Addendum No: 02

Project: Davis Elementary School, LUSD

Issue Date: 08/04/2026

PBK Project No: 230217 / DSA # 02-123250

E1.01

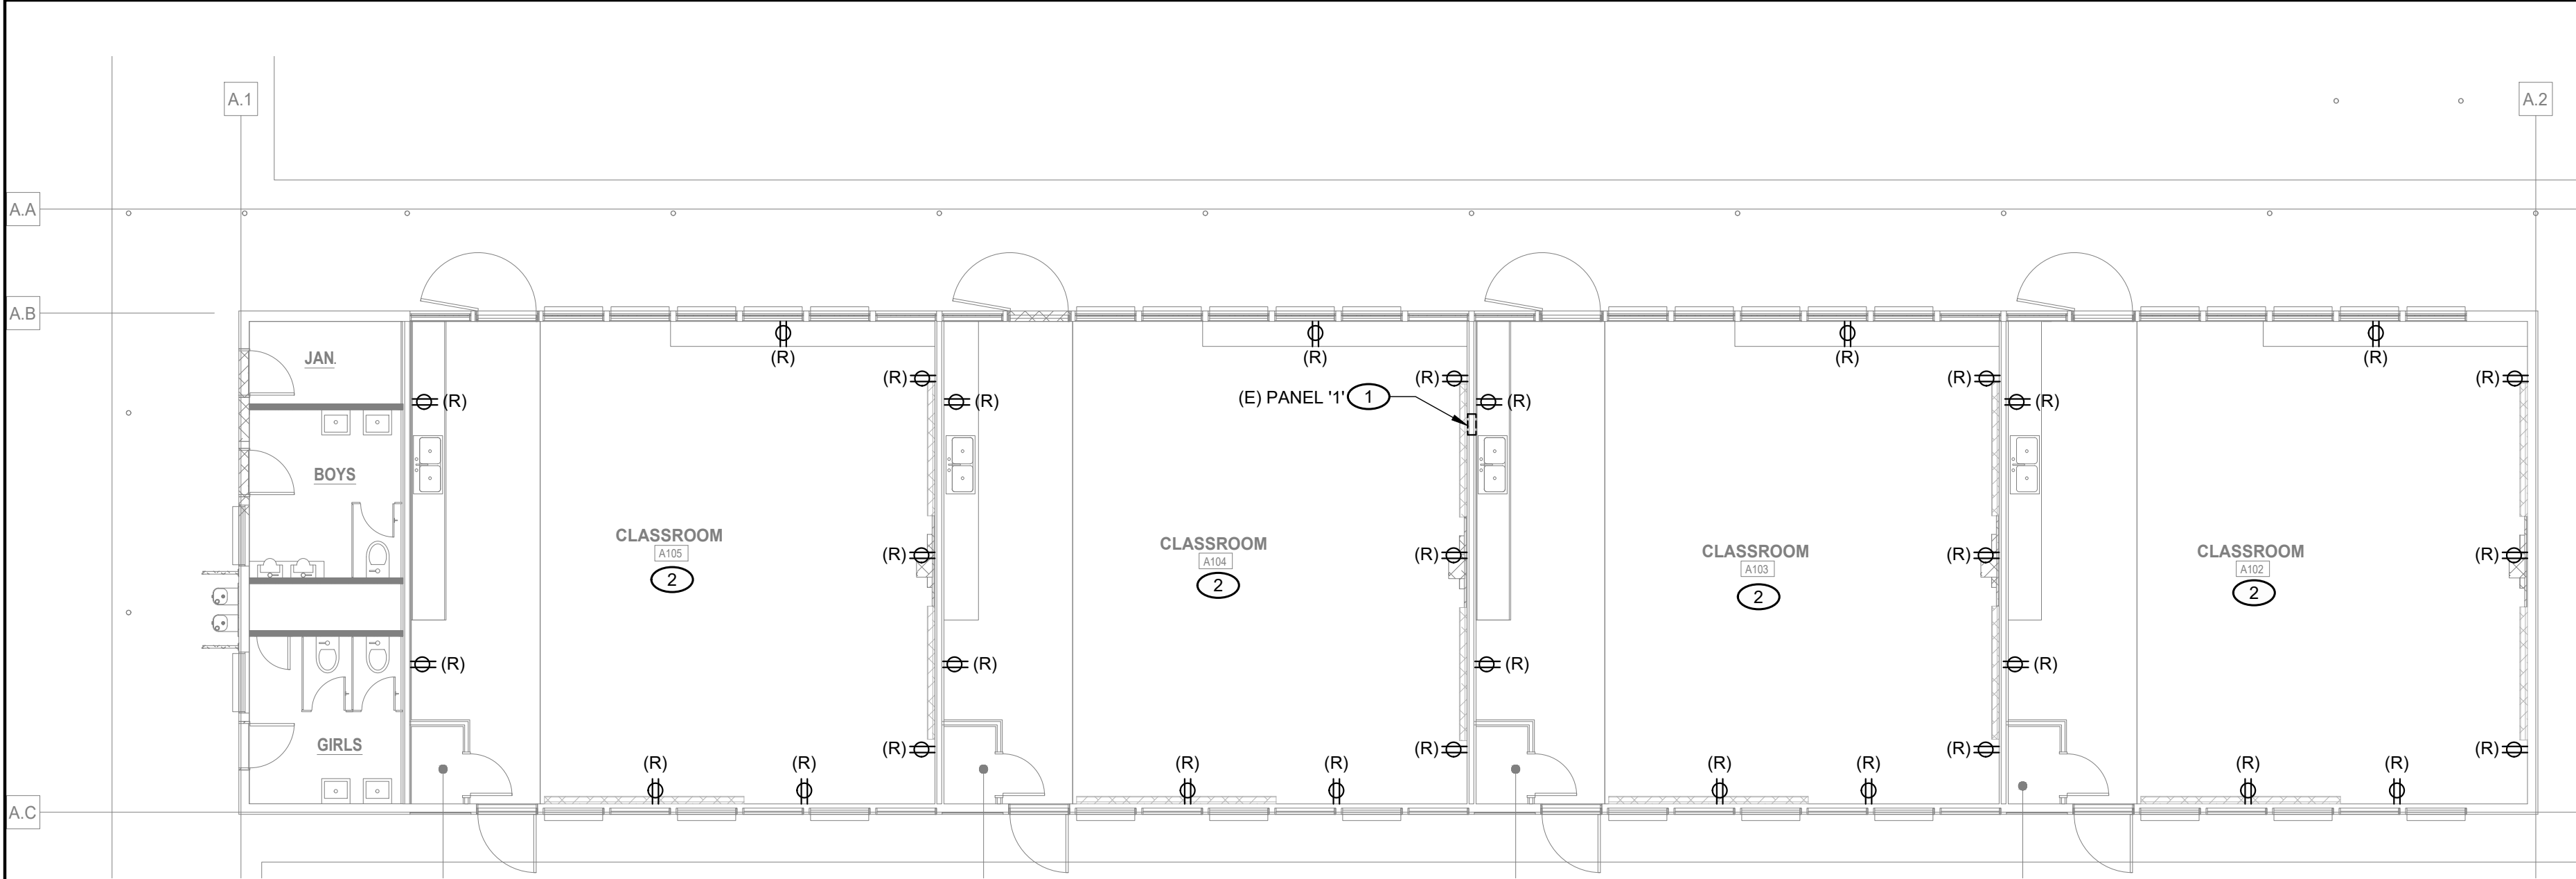
- Item 12. Replace sheet E1.01 – Electrical Site Plan with the attached sheet showing additional EV charger conduits.
- Item 13. Replace sheet ED2.01 – Electrical Demolition Floor Plans with the attached sheet showing modified Key Note #1.

E2.01

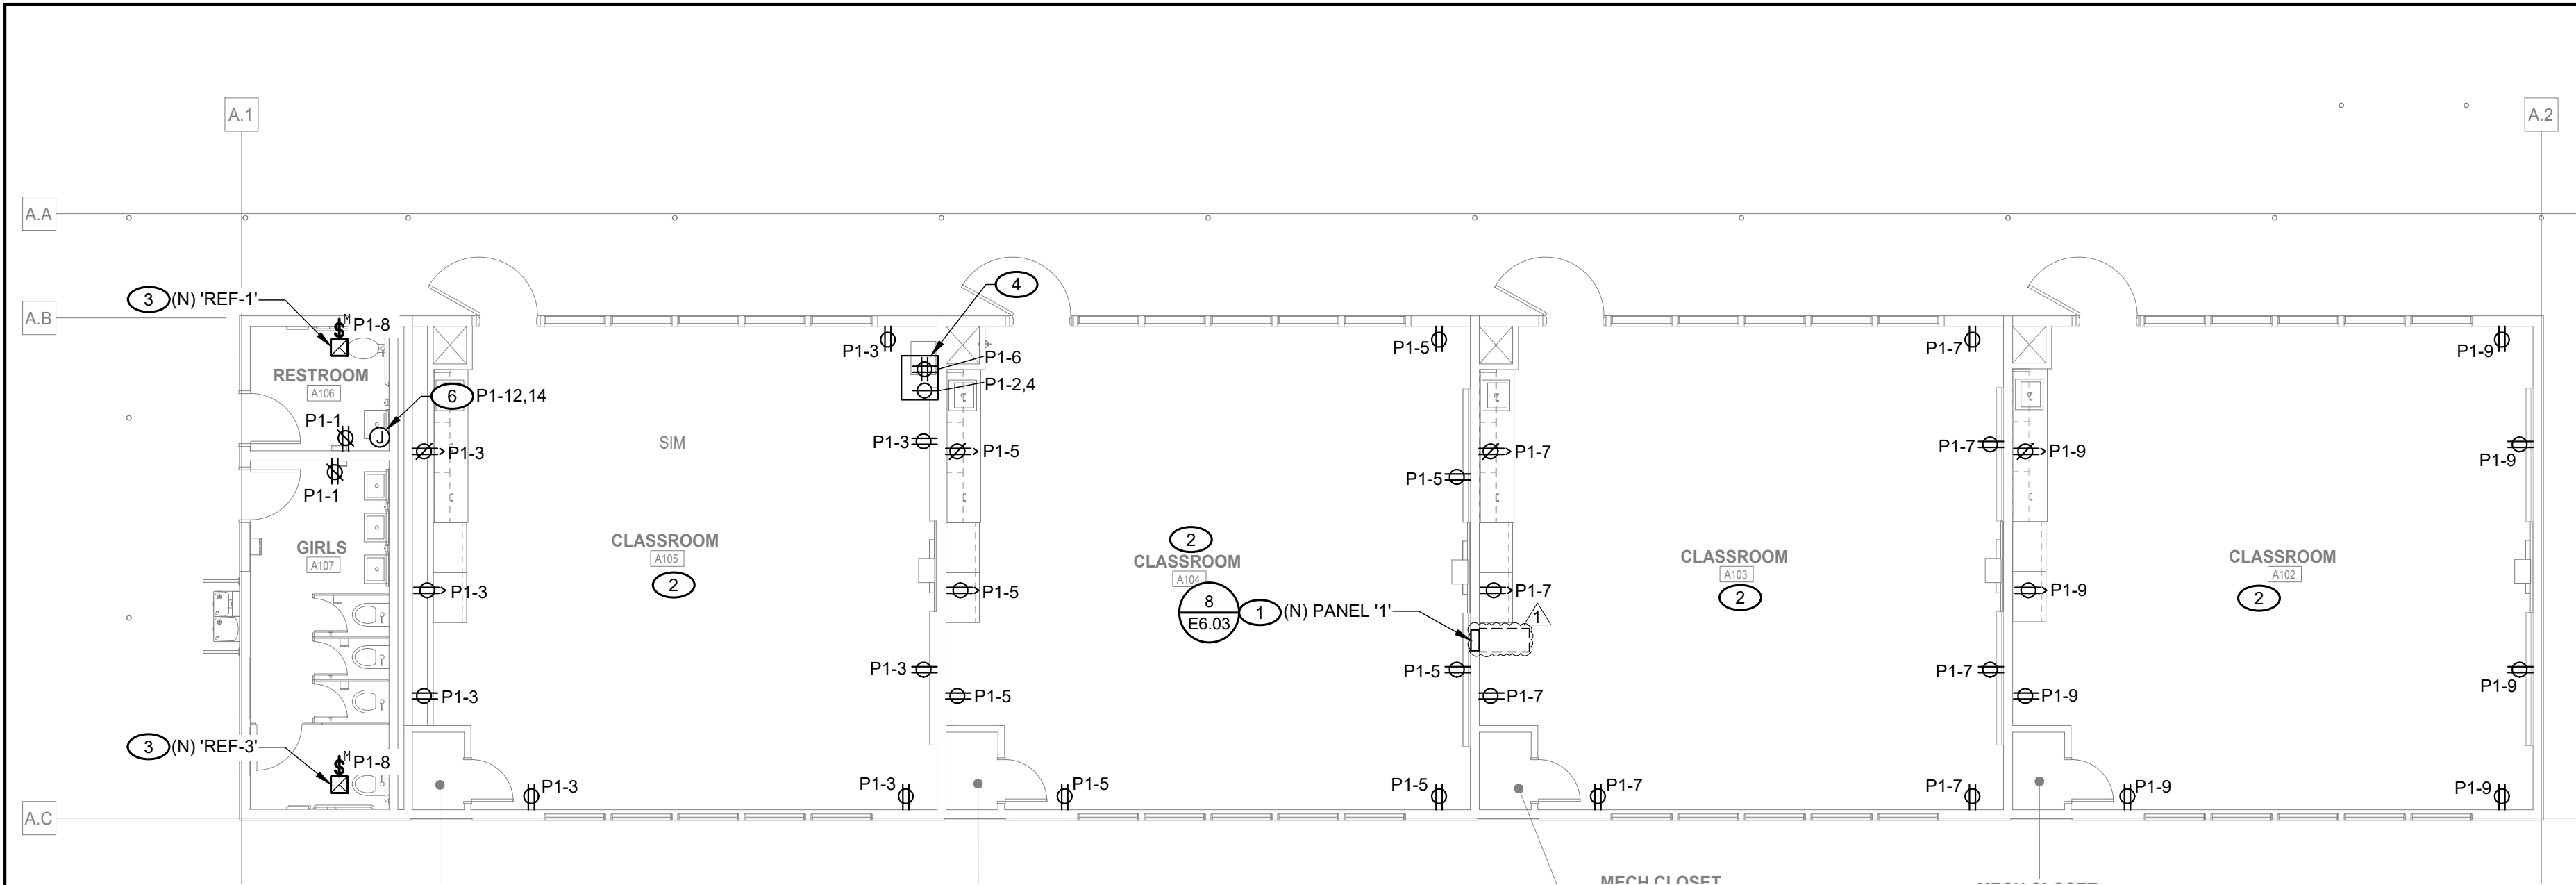
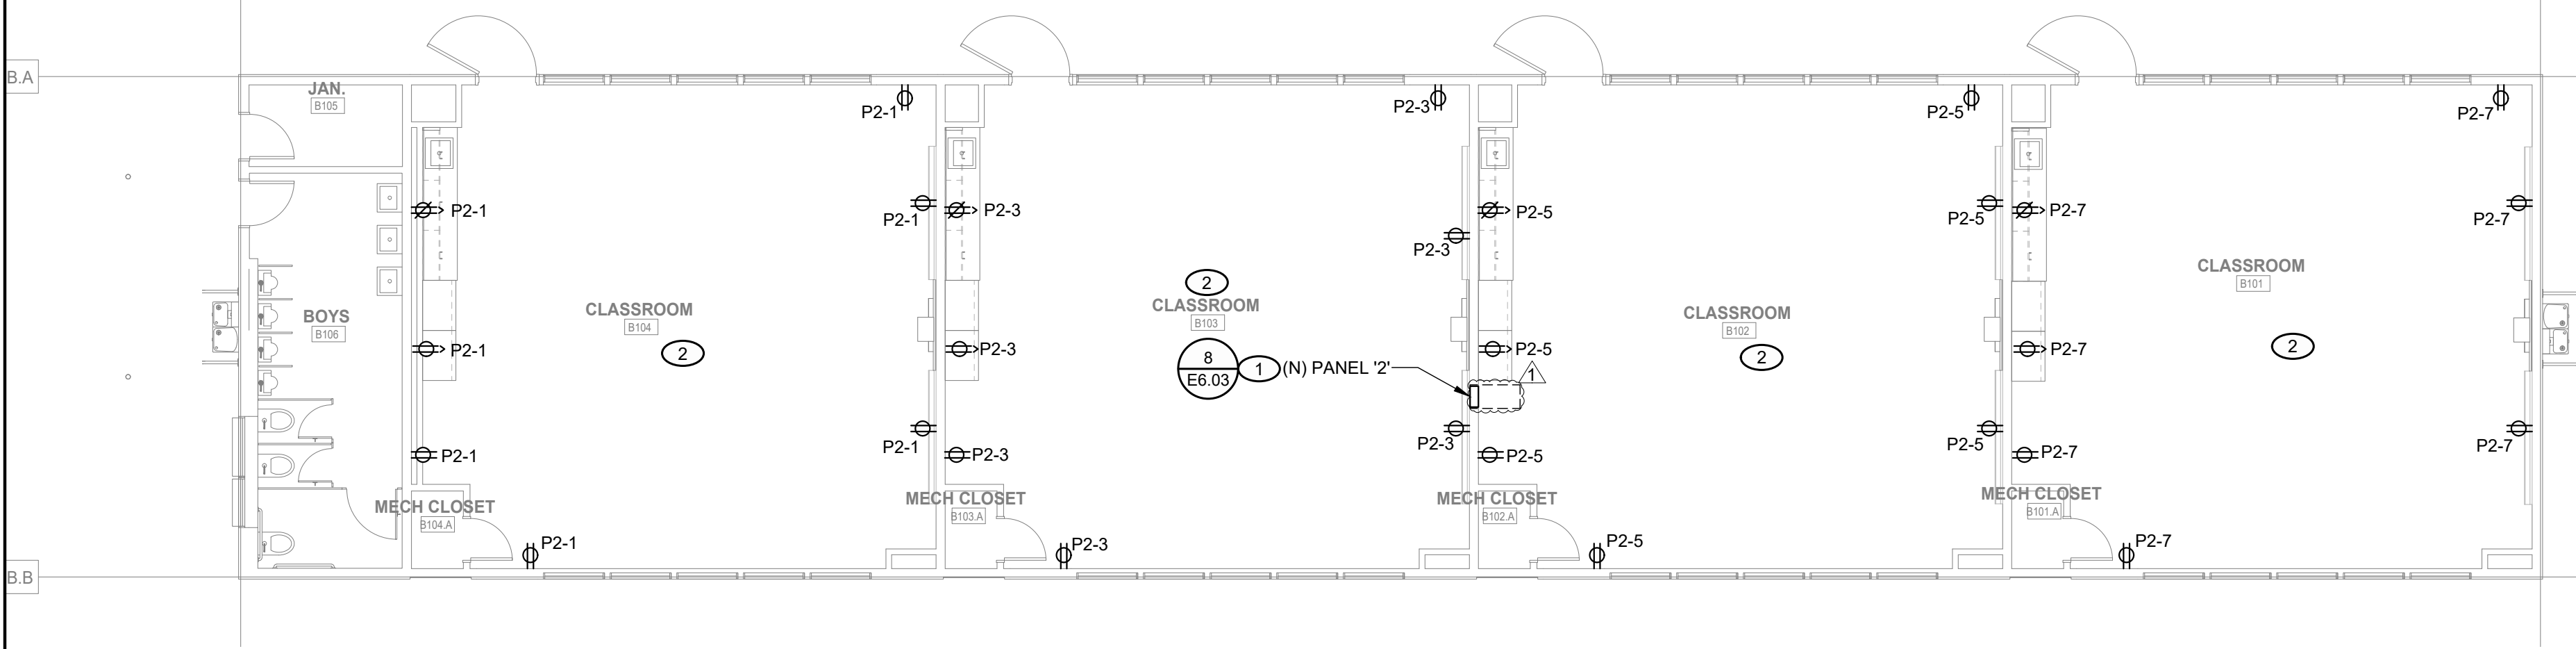
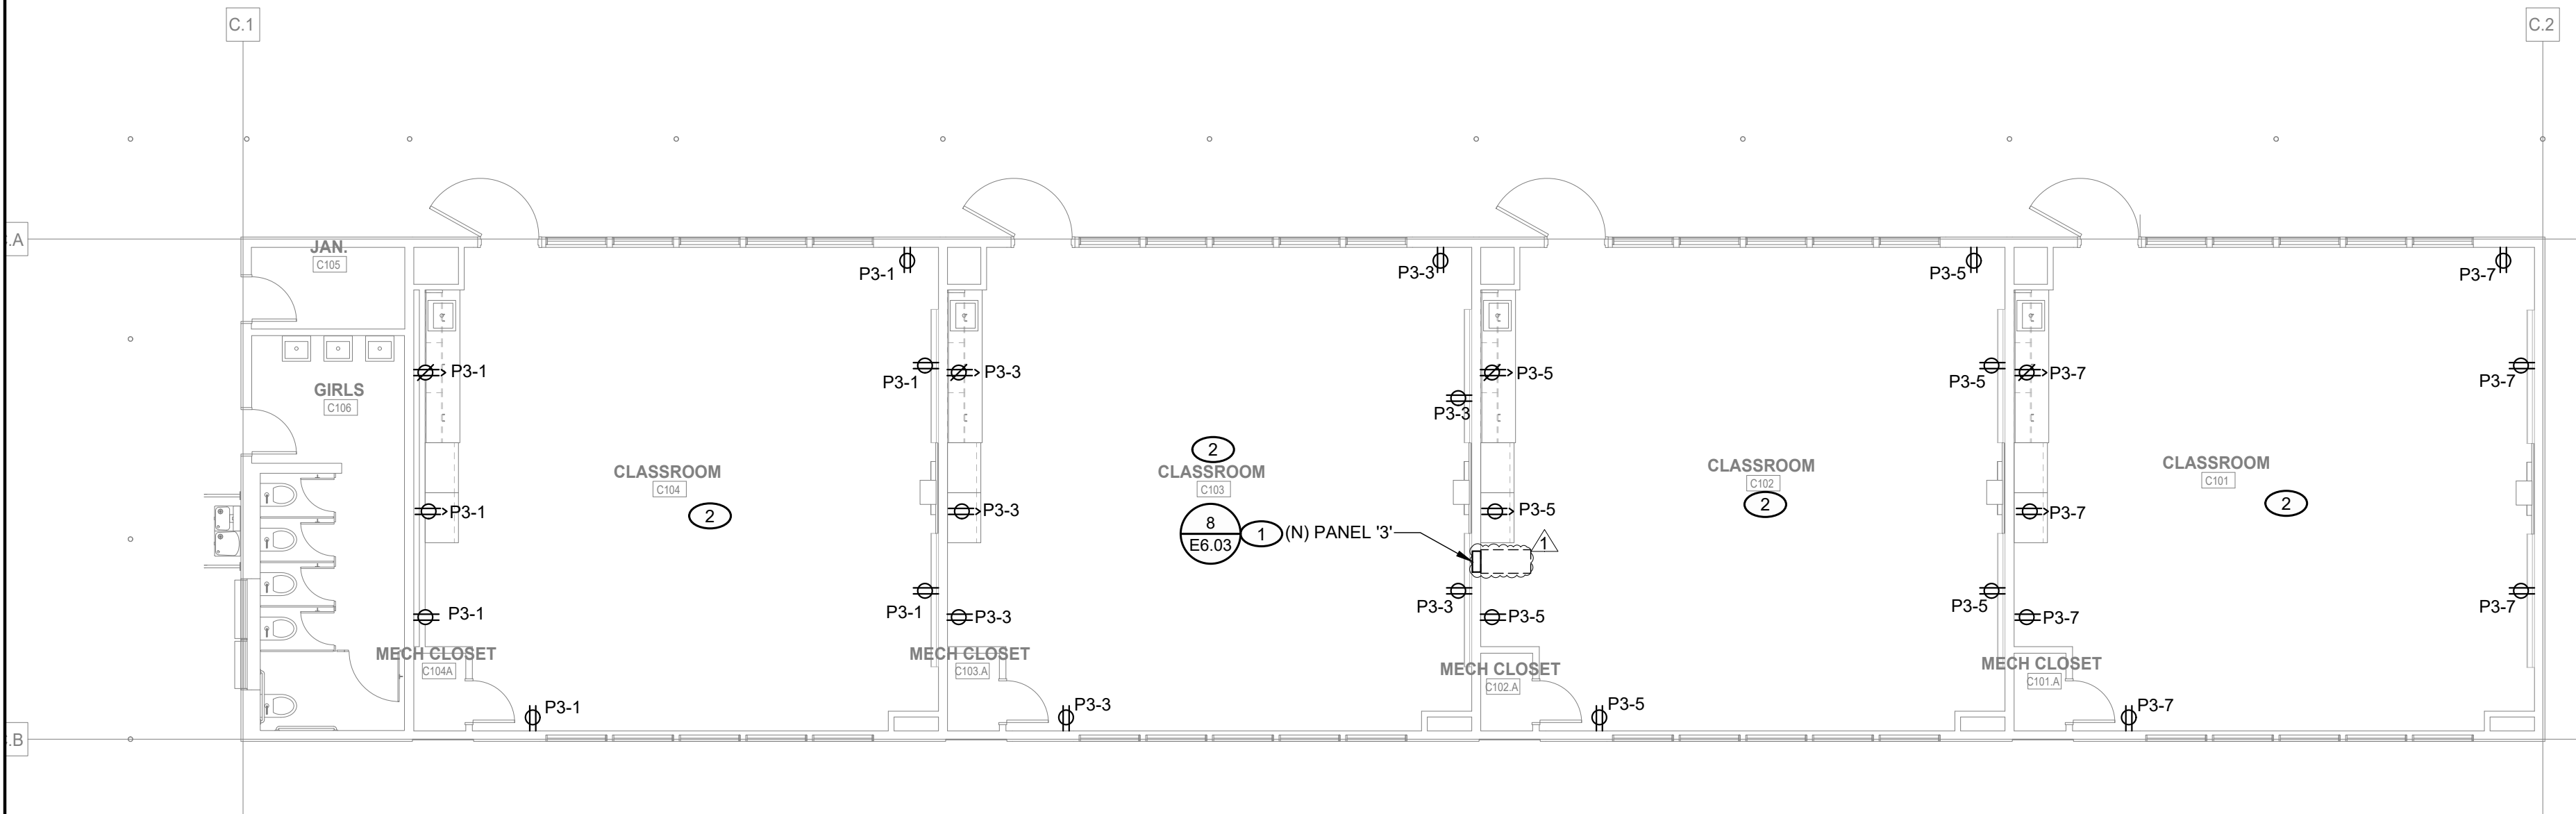
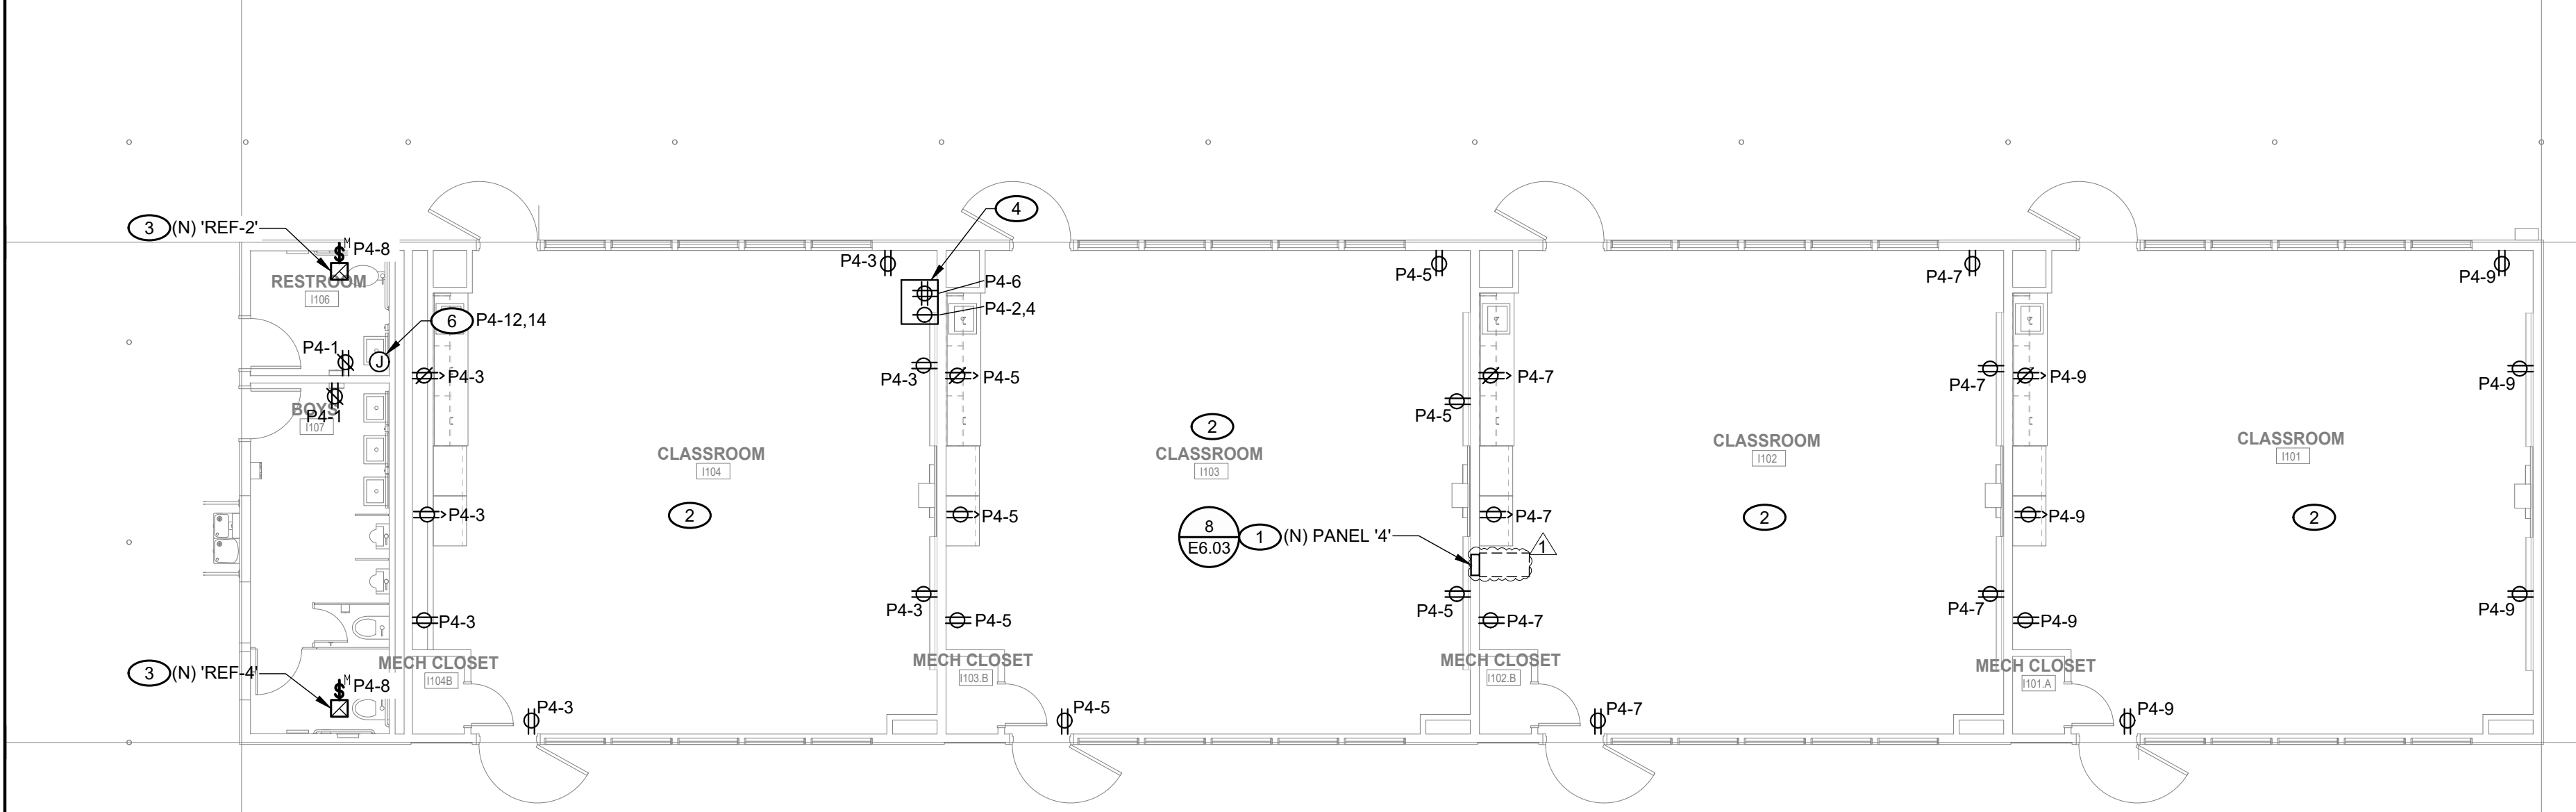
- Item 14. Replace sheet E2.01 – Electrical Floor Plan with the attached sheet showing a new panel in Building H and updated Key Note #1 and General Note #1.

1. PROVIDE NEW 100A LOADCENTER, RECONNECT EXISTING FEEDER CONDUCTORS AND CONDUITS FROM DEMOLISHED PANEL'S ORIGINAL LOCATION AND EXTEND AS NECESSARY TO NEW PANEL LOCATION. SEE KEYNOTE #1 SHEET 'E2.01' FOR ORIGINAL PANEL'S LOCATION.
2. PROVIDE NEW POWER RECEPTACLES IN CLASSROOM. ALL DEVICES SHOWN ARE NEW AND ARE TO BE PROVIDED BY THE ELECTRICAL CONTRACTOR.
3. PROVIDE POWER TO NEW ROOFTOP EXHAUST FAN FOR BATHROOM.
4. PROVIDE DEDICATED QUADPLEX NEMA 5-20 RECEPTACLE AND A DEDICATED NEMA L6-30 RECEPTACLE FOR IDF. COORDINATE LOCATION AND MOUNTING HEIGHT WITH TECHNOLOGY CONTRACTOR PRIOR TO INSTALLATION.
5. PROVIDE POWER TO NEW CEILING EXHAUST FAN FOR BATHROOM.
6. PROVIDE 208V, 1Ø POWER TO NEW INSTANT WATER HEATER.

1. ELECTRICAL PANELBOARDS AND LOADCENTERS INSTALLED IN PUBLIC (UNRESTRICTED) AREAS ARE TO BE SPECIFIED AND PROVIDED WITH LOCKABLE COVERS.
